Title : Replies to Pre Bid Technical queries and Other Clarifications.

Tender No : 3600001260 for “Engineering, Supply, Installation and Commissioning of CCTV System Augmentation in PPU Bagging Warehouse”

TITLE : MRPL FIBER & COPPER LINK DIAGRAM – PPU LAB

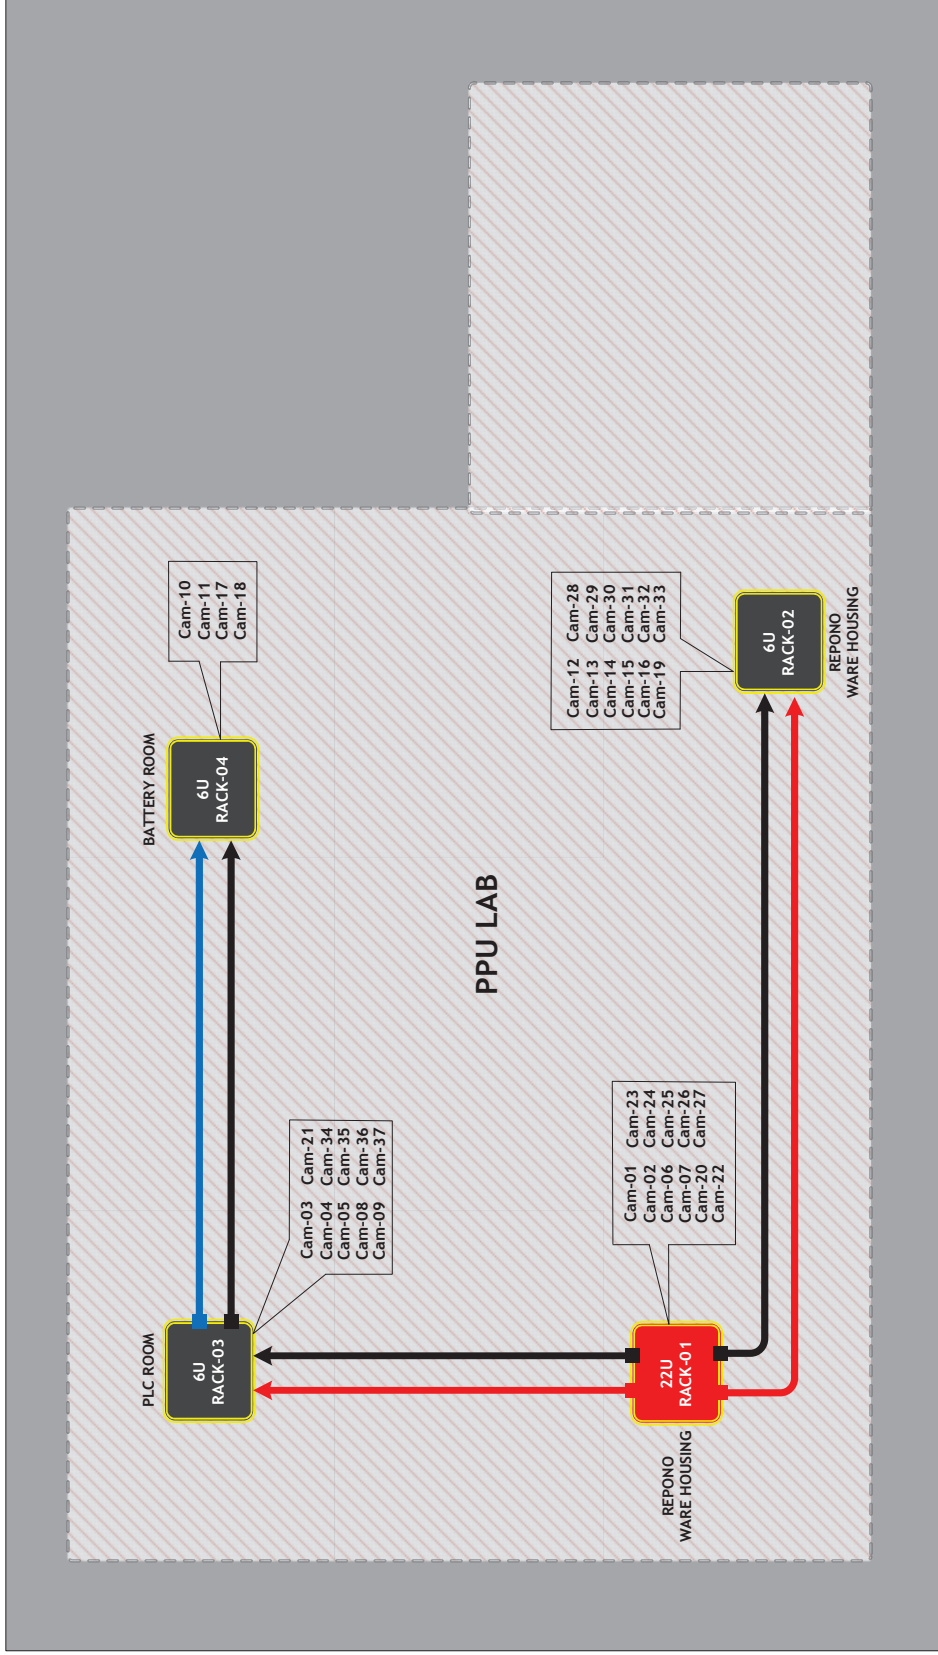
Sr. No.	Page No	Clause No.	Subject	Query	MRPL response																																																																
1	18	1. Introduction	The existing surveillance system in the PPU bagging warehouse has total of 37 cameras, 3 NVRs and 2 large display screens. MRPL is planning to augment this system with addition of 63 cameras, 2 large display screens and storage up to one year for all the cameras.	Details of existing system not provided in tender documents. Please share the same along with make/ models of existing installed cameras, NVR/Server, Storage, Switches, VMS etc. Also share system architecture, camera location, site layout of the existing system.

<ul style="list-style-type: none"> Basic system architecture of existing system is attached with this document. 	SL	ITEMS	Hardware in existing CCTV system	Make/ Model	1	IP Bullet Camera		Tyco - ISL02MFONWINUL	2	Network video recorder		Tyco - HOLNVR32-IN	3	40” Monitors		Samsung - PM43H	4	Video management computer		Dell - OptiPlex 3050	5	Surveillance HDD		Western digital	6	8 port POE switch		D-Link - DGS-1210-10MP	7	Shielded CAT6 cable		D-Link - NCB-C6SGRYR-305	8	Electrical Line Surge Protector		OBO Bettermann - V20-C 1+NPE-280	9	Cat 6 Surge Protector		OBO Bettermann - ND-CAT6A/EA	10	OFC Cable		D-Link 6 Core OFC - NCB-FS090-AUHD-06	11	22U Floor mounted rack		Netrack - FM-22U 600x600	12	9U Wall mounted rack		Netrack - WM SS-9U	13	6U Wall mounted rack		Netrack - WM SS-6U	14	RJ 45 Jacks		D-Link	15	Media Converter		D-Link DMC-G1000SC
SL	ITEMS	Hardware in existing CCTV system	Make/ Model																																																																		
1	IP Bullet Camera		Tyco - ISL02MFONWINUL																																																																		
2	Network video recorder		Tyco - HOLNVR32-IN																																																																		
3	40” Monitors		Samsung - PM43H																																																																		
4	Video management computer		Dell - OptiPlex 3050																																																																		
5	Surveillance HDD		Western digital																																																																		
6	8 port POE switch		D-Link - DGS-1210-10MP																																																																		
7	Shielded CAT6 cable		D-Link - NCB-C6SGRYR-305																																																																		
8	Electrical Line Surge Protector		OBO Bettermann - V20-C 1+NPE-280																																																																		
9	Cat 6 Surge Protector		OBO Bettermann - ND-CAT6A/EA																																																																		
10	OFC Cable		D-Link 6 Core OFC - NCB-FS090-AUHD-06																																																																		
11	22U Floor mounted rack		Netrack - FM-22U 600x600																																																																		
12	9U Wall mounted rack		Netrack - WM SS-9U																																																																		
13	6U Wall mounted rack		Netrack - WM SS-6U																																																																		
14	RJ 45 Jacks		D-Link																																																																		
15	Media Converter		D-Link DMC-G1000SC																																																																		
2	20	2.1.4	The bidder shall prepare system architecture, as built drawing and same shall be handed over to MRPL.	Please confirm whether to submit these documents with bid or after receipt of order.	Proposed system architecture shall be part of the bid.
